# CHANGE ORDER

**Sheriff Office Tenant Improvements – West Precinct**  
9829 24<sup>th</sup> Place West  
Everett, WA. 98204

Date: 01/02/2024  
CO No: PW23-007SB-06S  
Contract No: PW23-007SB

Drawing Number  
**P2.01**

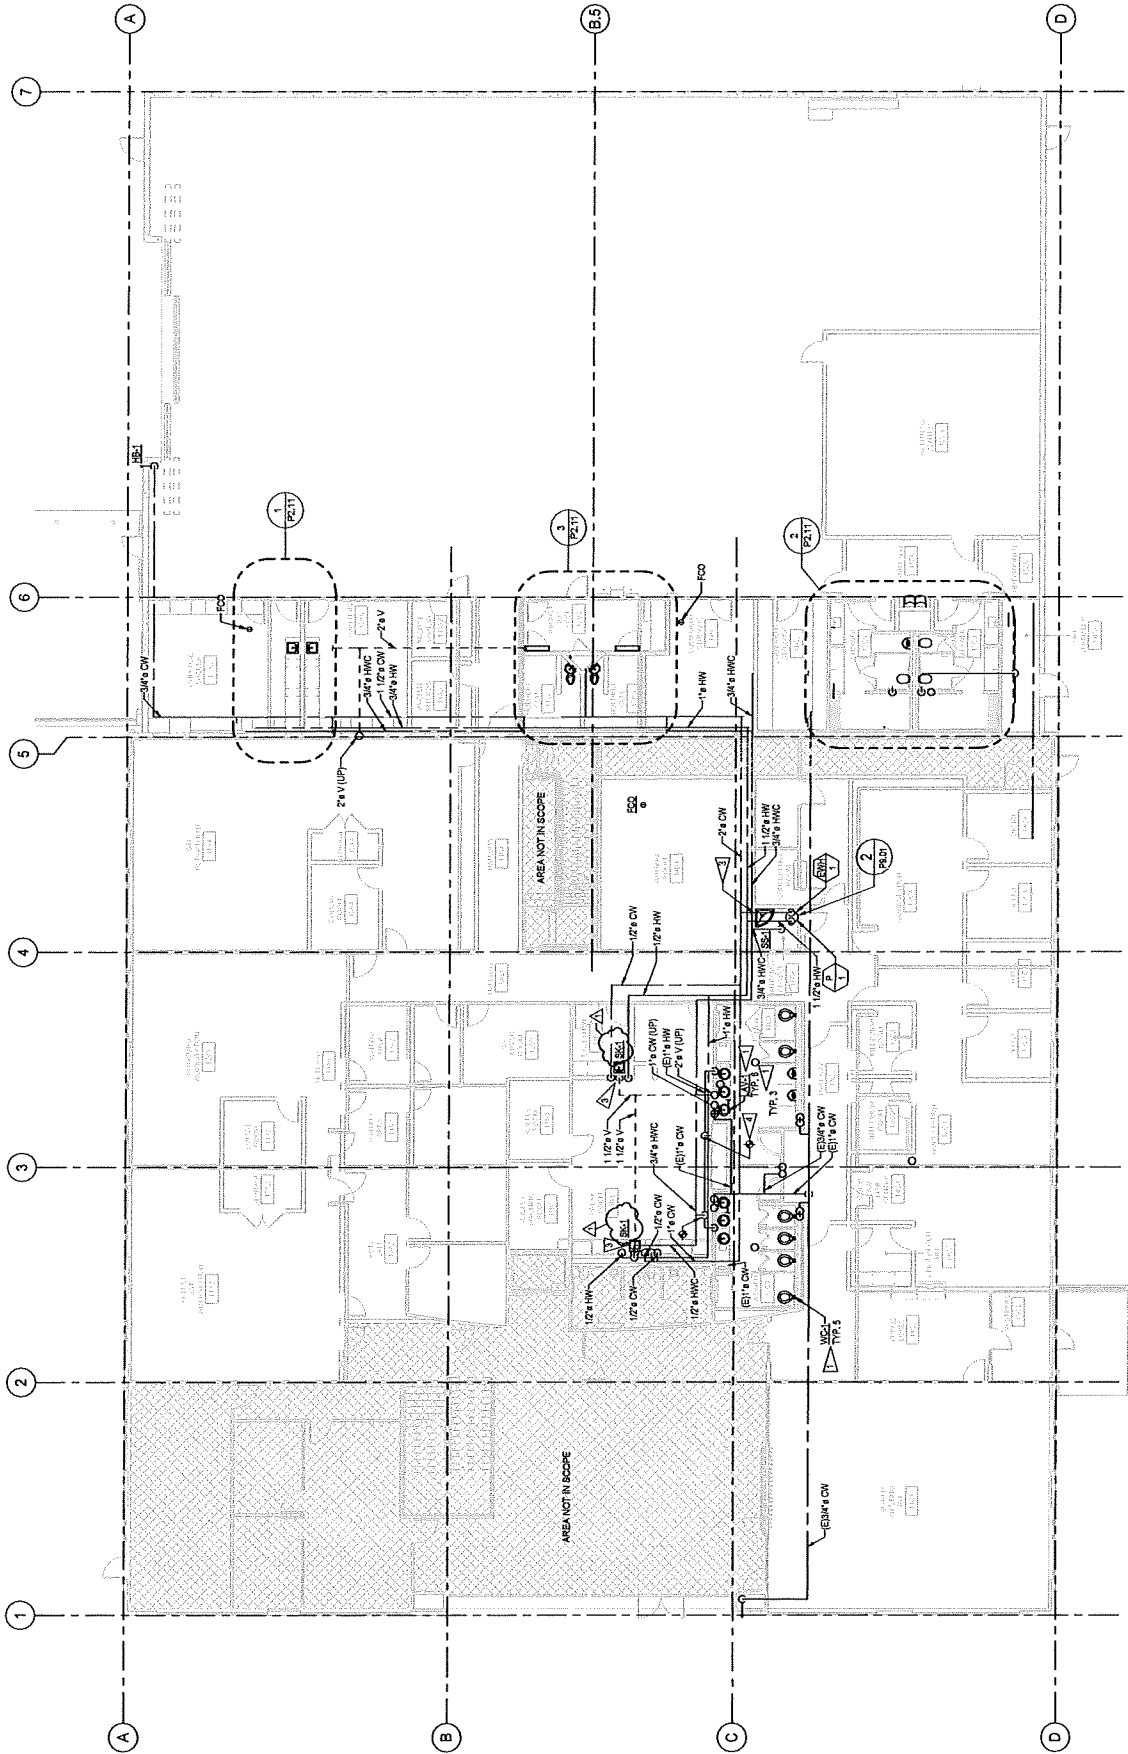
Revisions to: Water Heater voltage; Lav-1 sink type (revised from drop-in vitreous china to SS under-mount); SK-1 sink type (revised from oval SS sink to rectangular SS sink); SK-2 sink type deleted.

Drawing Number  
**A-143**

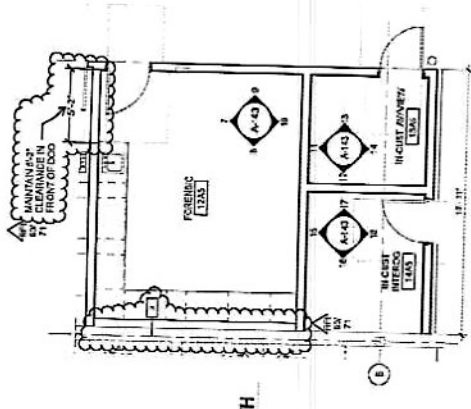
<b>COP</b>	007	<b>JOB NAME</b>	SC Sheriff West Precinct & Paine Field T1	<b>DATE</b>	12/12/23
<b>GENERAL CONTRACTOR</b>	Western Ventures Construction		<b>REFERENCE DOCUMENT</b>	RFI #71	
<b>DESCRIPTION</b>					
This COP is for our costs associated with RFI #71 added furred wall in room #14A5 In-Cust Interrogation.					
<b>PREPARED BY:</b>		Conor Palomarez

\* The Interview Room is 14A5 In-Cust InterOg. That was missed from RFI-071, but from your response it sounds like we need to include the furring.

**Question from Jason Marion Western Ventures Construction Inc on Wednesday, Oct 18, 2023 at 02:30 PM PDT**  
At the following locations there are conflicting notes in the plans for wall types. Please review and advise on how we are to proceed.

**Response from Richard Murakami Rolluda Architects on Thursday, Nov 2, 2023 at 03:53 PM PDT**

Drawing Number  
**ED2.01**

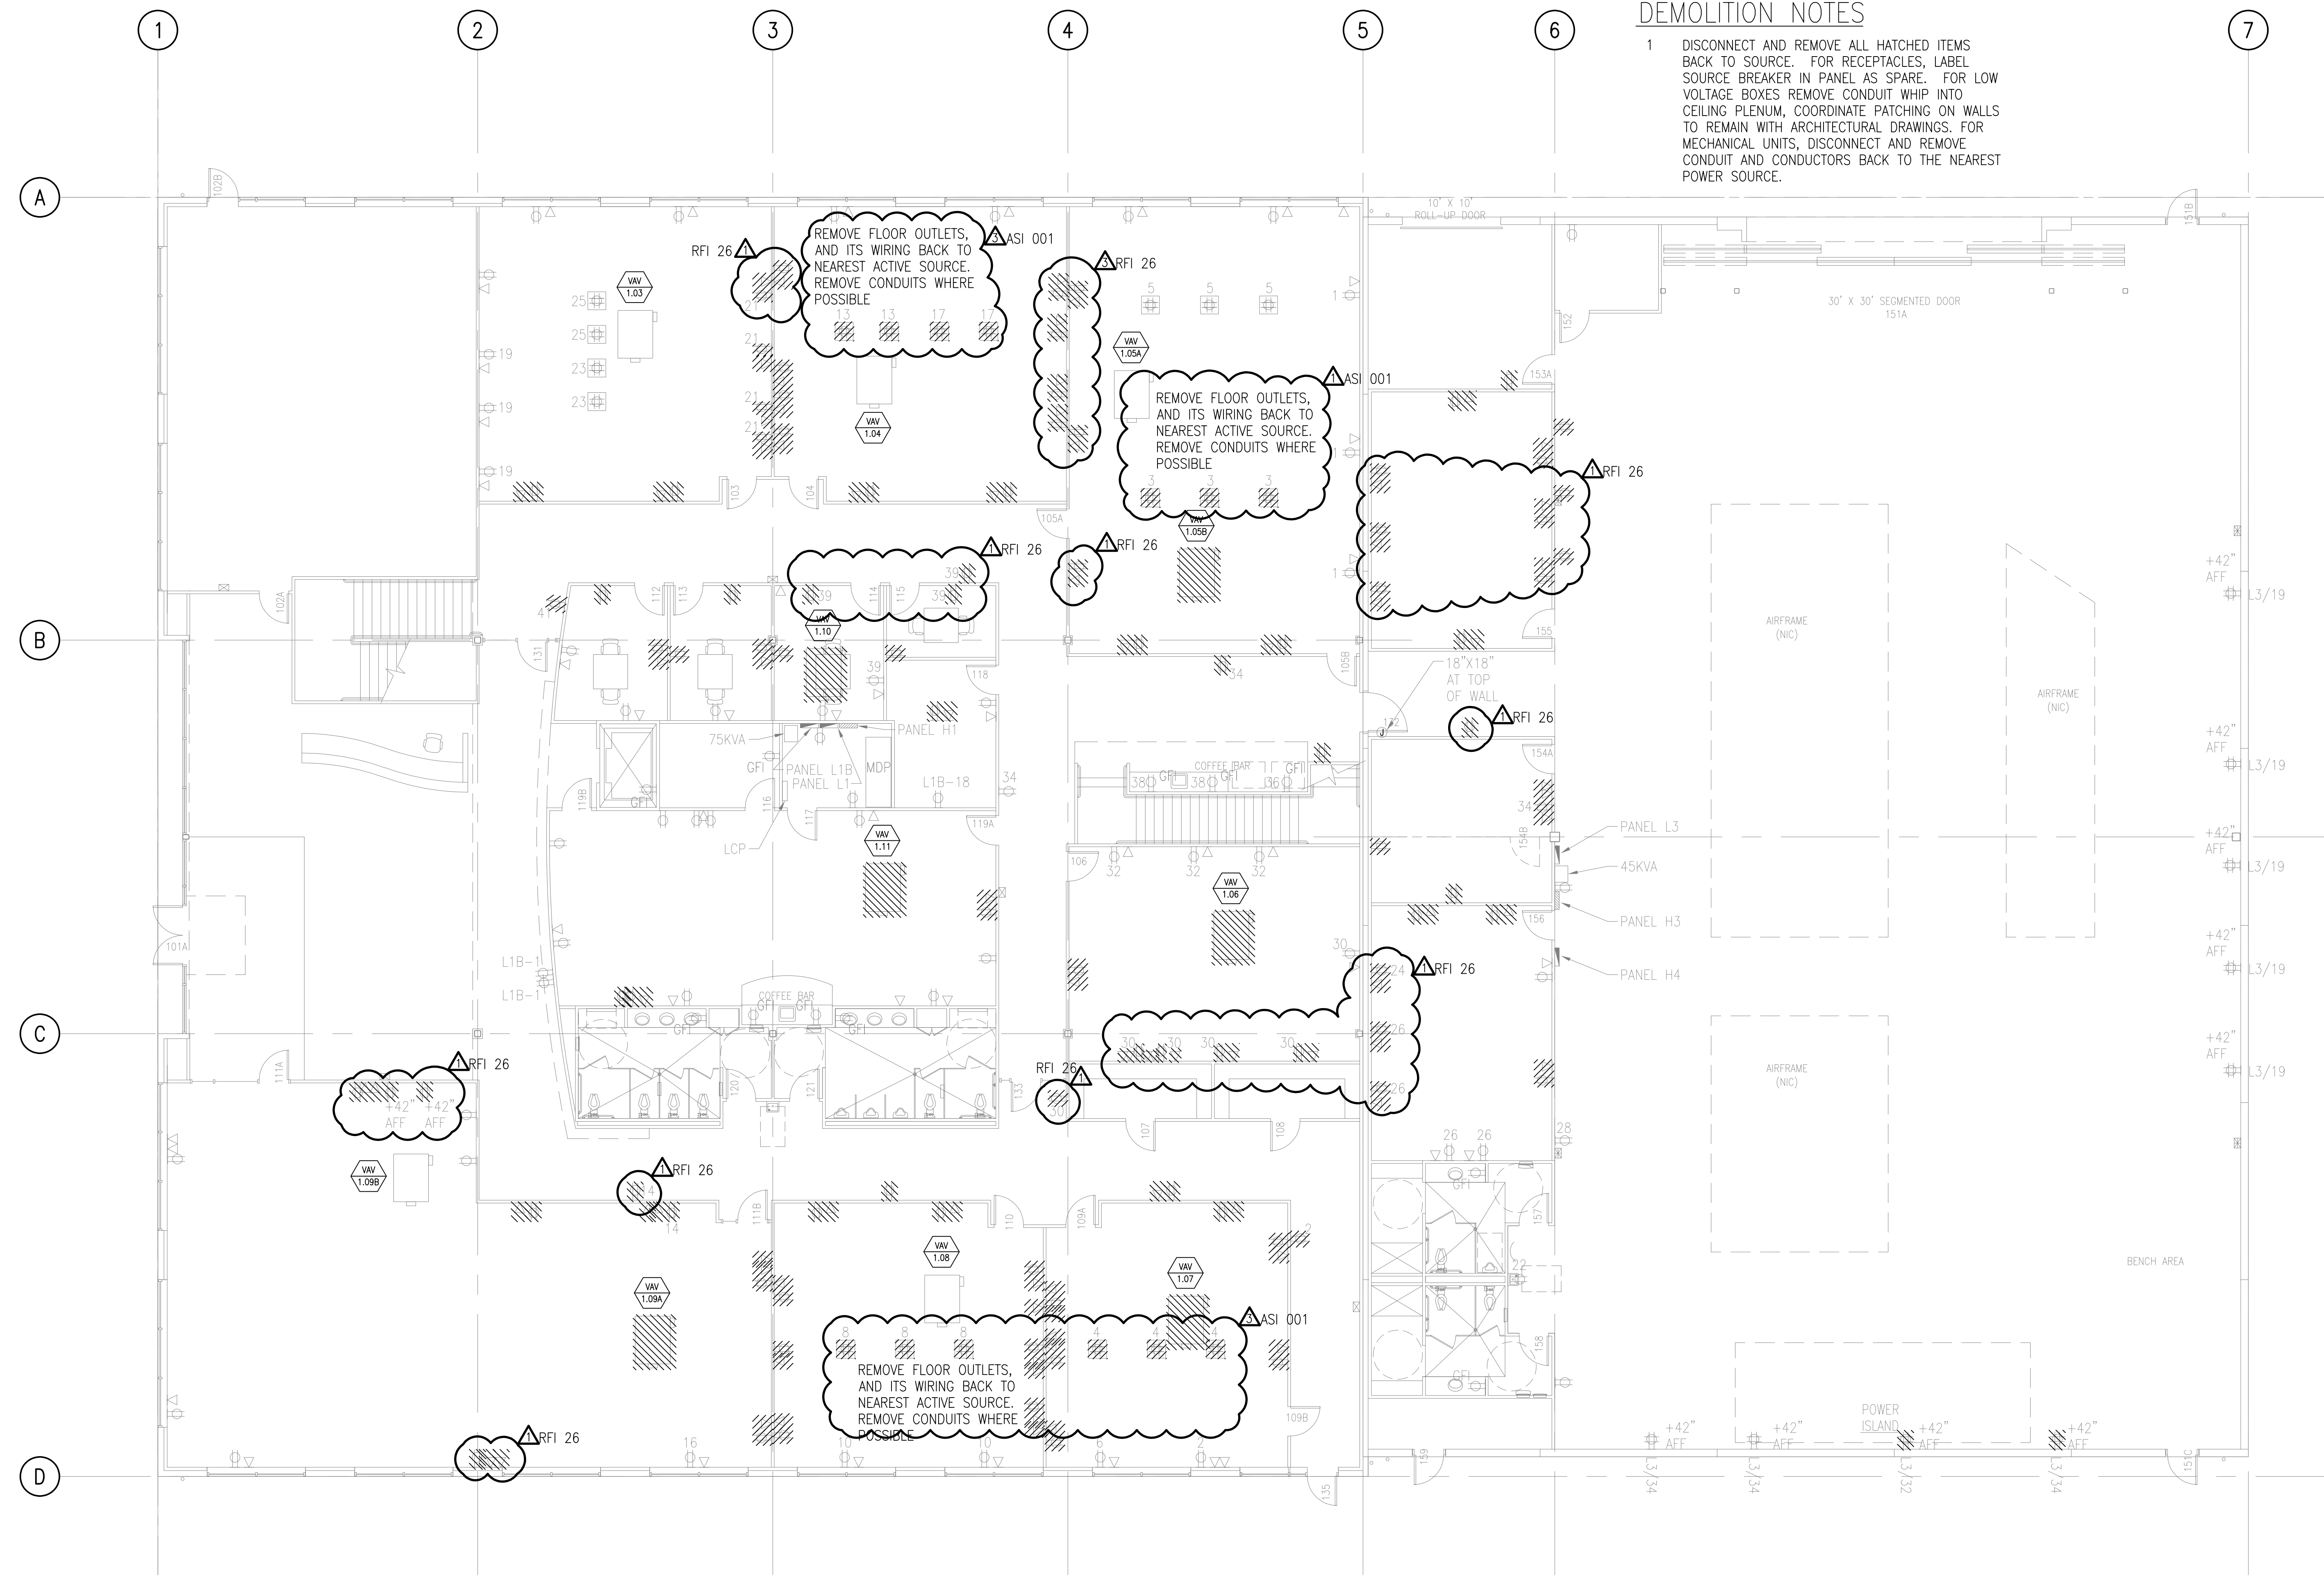
**Question from Jason Marion Western Ventures Construction Inc on Sunday, Sep 24, 2023 at 10:25 AM PDT**  
 There are existing electrical floor boxes in conflict with the wall layout in three locations, east wall of offices 16C3, 15C3, 15C4 and 14C4, west wall of 11A3 and west wall of 13A4 and 12A4.

**Response from Richard Murakami Rolluda Architects on Wednesday, Sep 27, 2023 at 08:17 AM PDT**  
 FLOOR BOXES ARE NOT NEEDED. ONLY REMOVE THE ONES IN CONFLICT WITH THE NEW WALLS.  
 PLEASE DISCONNECT AND REMOVE CONDUCTORS BACK TO THE NEAREST POWER SOURCE THAT IS TO REMAIN. REMOVE CONDUITS WHERE POSSIBLE.  
 FILL THE HOLE IN THE SLAB.  
 MAHMOOD NAMAZI  
 CASNE ENGINEERING  
 09/27/2023

Per response to RFI 044: Remove existing floor boxes in conflict with new walls. Disconnect and remove conductors back to the nearest power source that is to remain. Remove conduit where possible. Fill hole in slab.

1.6.07.002  
 BID SET  
 Drawing Title  
**CODE PLAN -  
SECOND FLOOR**  
 Drawing Number  
**G1.03**

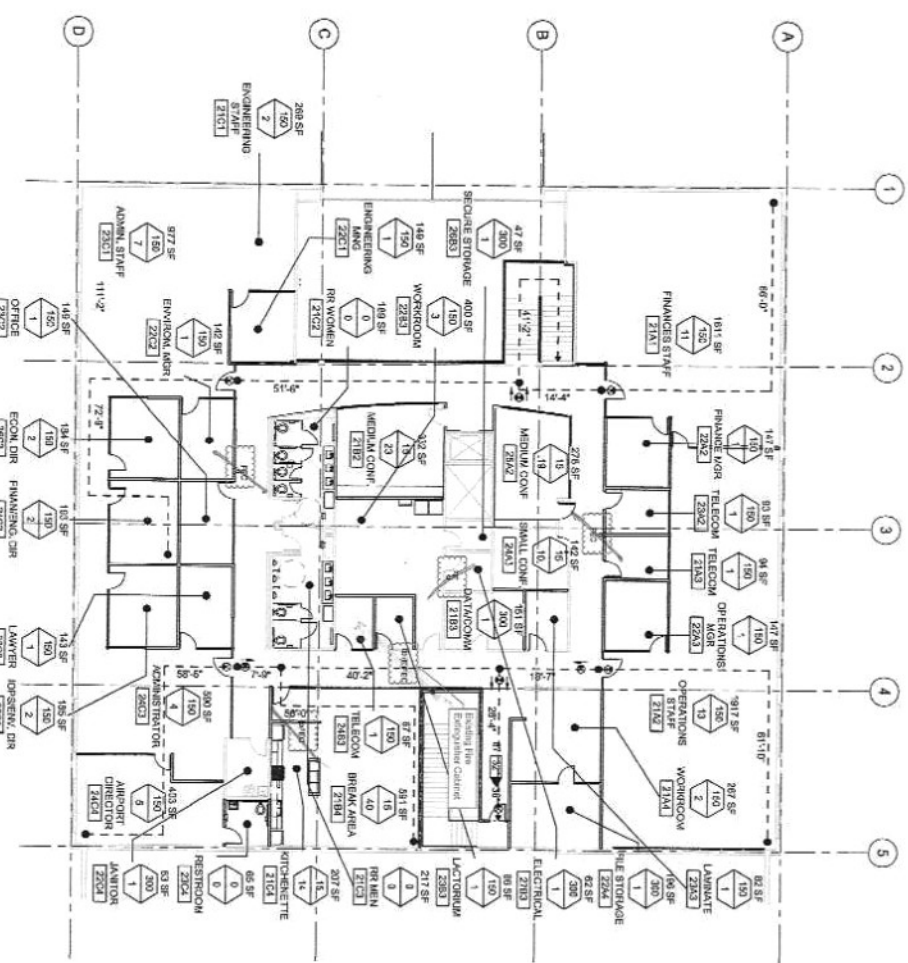
Per the attached sheet G1.03, received with the permit drawings for Airport, there is a quantity of 12 EA Fire Extinguishers that are without cabinets, and 1 EA with cabinet. The location of the 1 EA cabinet (circled in BLUE) is in an existing 3-5/8" wall. This cabinet would need to be semi-recessed. The original G-1.03 plan with the bid set shows ZERO EA fire extinguishers/cabinets, so all extinguishers and cabinet would have a cost.
